[Docket No. FAA–2018–0893; Product Identifier 2018–SW–032–AD; Amendment 39–21319; AD 2020–23–03]

Airworthiness Directives; Airbus Helicopters

2020–23–03 Airbus Helicopters:

Figure 1 to Paragraph (f)(1)

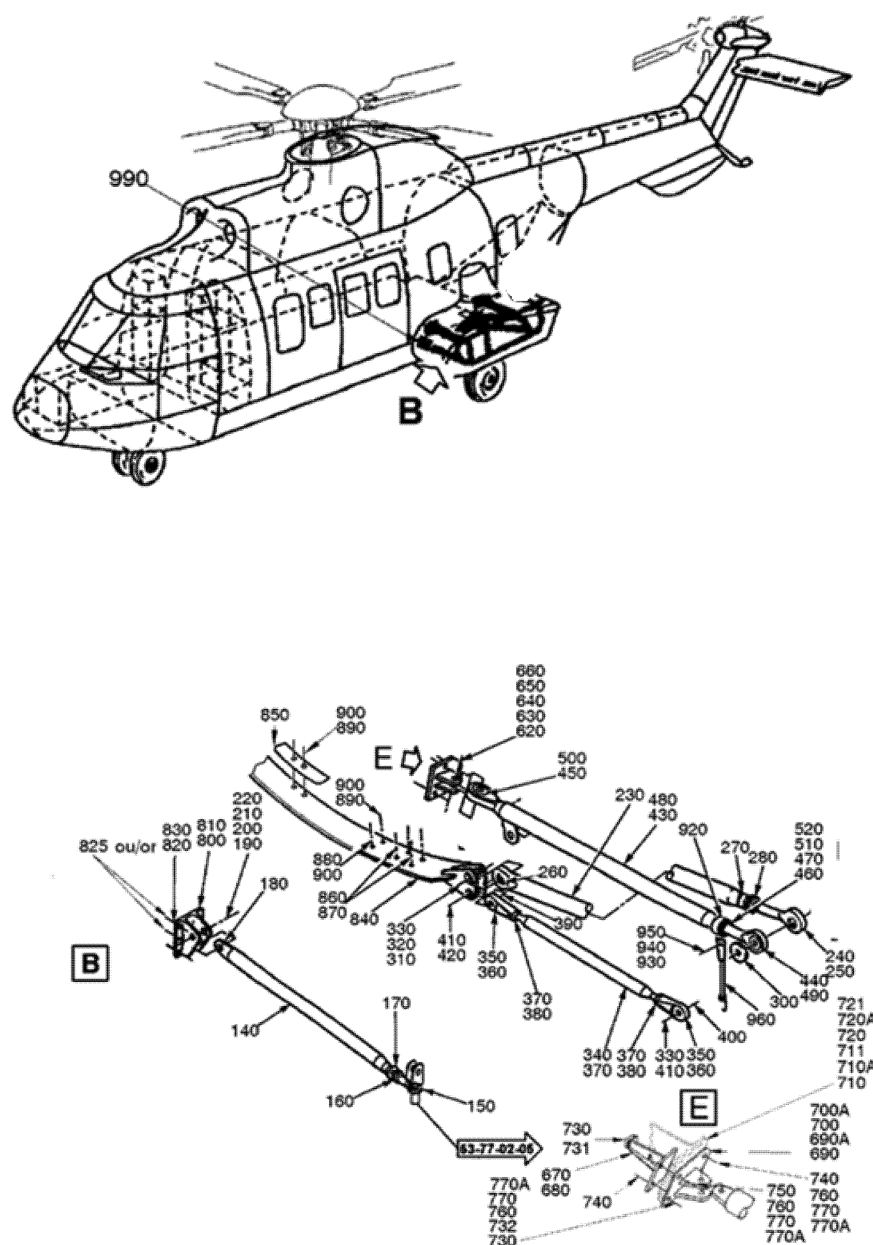
(1) Within 15 hours time-in-service (TIS), and before each flight over water thereafter, visually check each emergency flotation gear left hand (LH) and right hand (RH) rear upper fitting to determine whether the heads of the lower screws are present. Figure 1 to paragraph (f)(1) of this AD depicts where the lower three screws (noted as B and E) are located. Check each screw for looseness by determining whether it can be rotated by hand. These actions may be performed by the owner/operator (pilot) holding at least a private pilot certificate and must be entered into the aircraft records showing compliance with this AD in accordance with 14 CFR 43.9(a)(1) through (4) and 14 CFR 91.417(a)(2)(v). The record must be maintained as required by 14 CFR 91.417, 121.380, or 135.439.

(2) If a screw head is missing, or if a screw is loose, before further flight over water, install MOD 0728456 by completing paragraph (f)(3) of this AD.

(3) Within 300 hours TIS, unless required before further flight over water by paragraph (f)(2) of this AD, install MOD 0728456 by doing the following:
